**R66 Ammeter Installation Upgrade Kit Instructions**

*For use when replacing existing G143-2 Ammeter with G143-3 Ammeter (not included in kit), originally installed on R66 S/N 0520 thru 1004 (except 0795 & 0983). Kit provides upgrade for electrical connections.*

**FIGURE 2A Existing schematic**

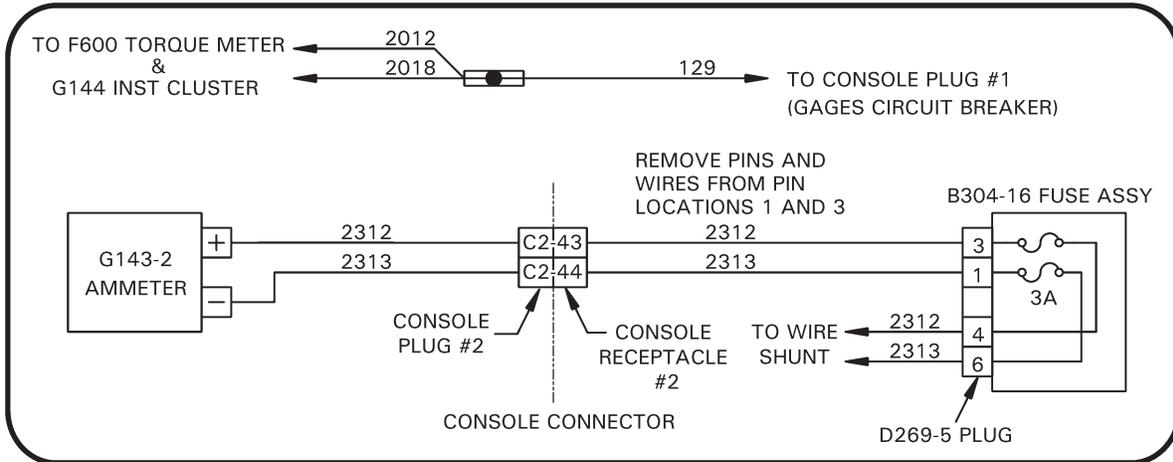
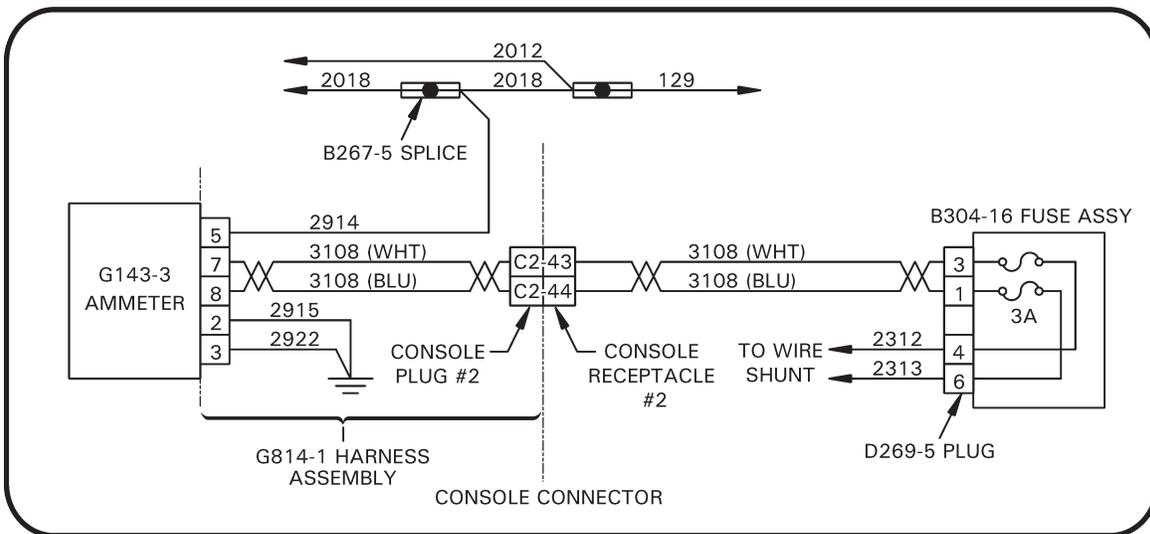
7. Refer to Figure 2A and MM Figure 98-2A. Remove and discard wires (-2312) & (-2313) from console plug #2 locations 43 & 44.
8. Refer to Figure 2B. Install G814-1 harness assembly:
  - a. Insert sockets of wires (-3108) to console plug #2, with white (WHT) wire in location 43, and blue (BLU) wire in location 44.
  - b. Attach B260-3 terminal to ground on any available terminal of console bus bar.
  - c. Splice wire (-2914) into wire (-2018) from instrument cluster, using B267-5 solder sleeve splice. Apply heat using heat gun to solder sleeve splice until indicator ring and solder sleeve are completely melted.
9. Install G143-3 ammeter per MM § 95-42D, connecting G814-1 harness assembly to ammeter.

10. Refer to Figure 2A. Locate and remove wires (-2312) and (-2313) & associated pins from receptacle #2 in lower console, shown in MM Figure 98-2A as "C2-43" and "C2-44". Install pins of KI-283-3108 wire assembly in vacated receptacle locations, with white (WHT) wire (-3108) in location 43, and blue (BLU) wire (-3108) in location 44.

12. Refer to Figure 2A. Locate B304-16 fuse assembly secured to main harness wire bundle, aft side of firewall. Cut ty-raps as required to access D269-5 plug. Using pin extractor, remove pins of wires (-2312) and (-2313) from plug pin positions 1 & 3. Discard removed wires.

13. With KI-283-3108 wire assembly secured to main harness and using extracted wires as guide, cut blue and white wires (-3108) to length. Strip ends of wires and crimp (1) M39029/58-360 pin to each wire using 8-impression crimp tool. Verify pin security. Install wires into D269-5 plug per schematic in Figure 2B. Connect plug to B304-16 fuse holder assembly and secure using MS33567-4-9 ty-rap. Secure to wire bundle using appropriately sized ty-raps as required.
